Subject: Three Mile Island Nuclear Station Unit 2
Operating License DPR-73
Docket No. 50-320
Heavy Load Handling Over the TMI-2 Reactor Vessel

SAFETY EVALUATION BY THE OFFICE OF NUCLEAR REACTOR REGULATION

HEAVY LOAD HANDLING OVER THE TMI-2 REACTOR VESSEL

INCORE INSTRUMENT GUIDE
TUBE / NOZZLE INTERFACE

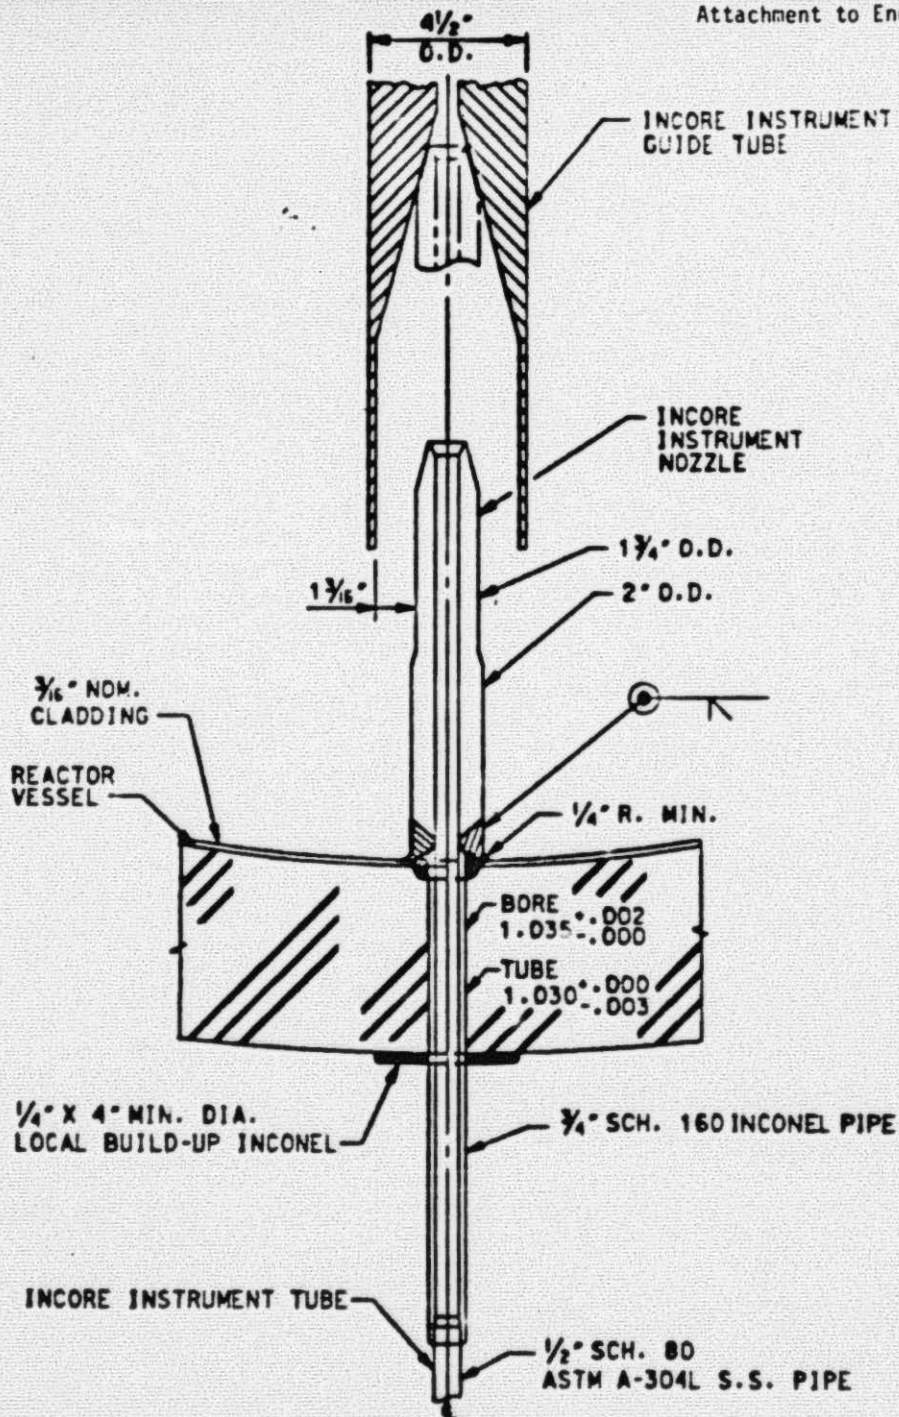
The worst case potential accident resulting from a load drop onto the reactor vessel would be the breach of the incore instrument tubes which penetrate the bottom of the vessel. These tubes were previously addressed in the licensee's SER for the Removal of the Reactor Vessel Head dated March 9, 1984, which was approved by the staff on July 17, 1984. However, when considering the recently viewed lower core damage, there is a higher probability that some damage did occur to the incore instrumentation tube area. Therefore, the licensee has postulated all 52 tubes breaking, resulting in a 0.010 inch circular annular gap for each tube.

This leakage pathway is based on the licensee's conclusion that none of the failure mechanisms will cause the 3/4" Inconel tube to fall out of the vessel (see Figure 1). The staff, after several discussions with the licensee and our independent review, concurs with this conclusion.
